City of Richmond

Report to Development Permit Panel

File: DP 16-741123

Re: Application by Christopher Bozyk Architects Ltd. for a Development Permit at
13100 Smallwood Place

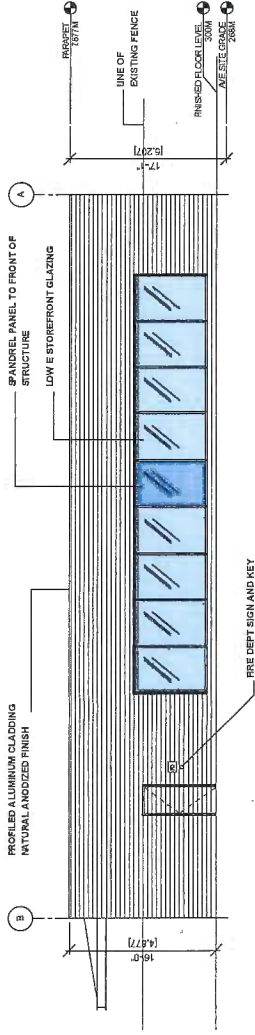
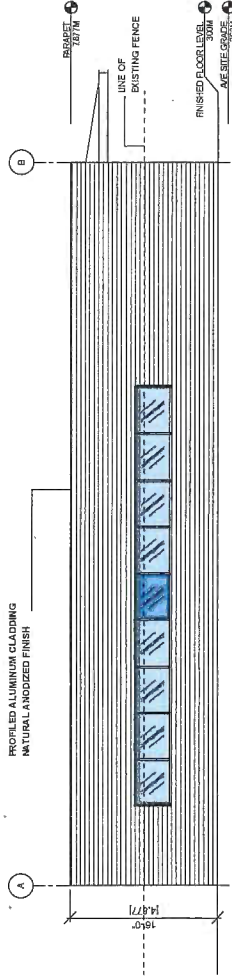
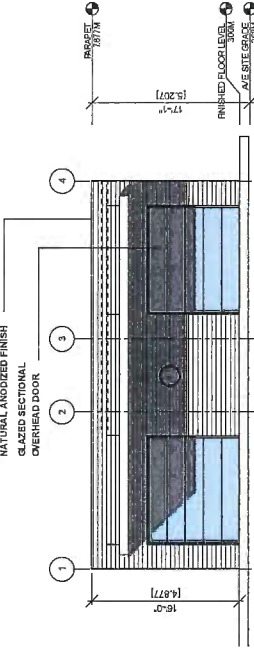
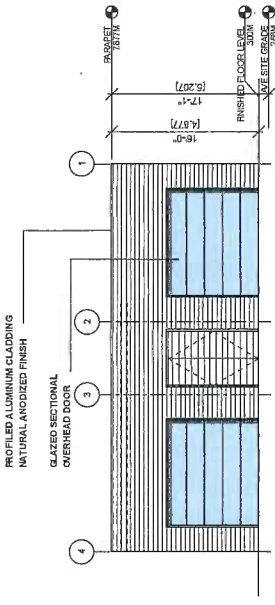
- long linear treatment of the building on Westminster Highway elevation reduces the scale of the building; proposed parapet height appears adequate to provide screening to parked vehicles on the roof top; however, slightly increasing the parapet height could help;

- appreciate the outdoor deck at the east end of the south elevation;
- appreciate the metal mesh sun shading at the northwest corner; and
- investigate visibility of parked cars on rooftop parking at full capacity particularly at the northwest corner and consider increasing the parapet height if necessary.

The parapet height has been increased by 8" to help increase screening of parked cars.
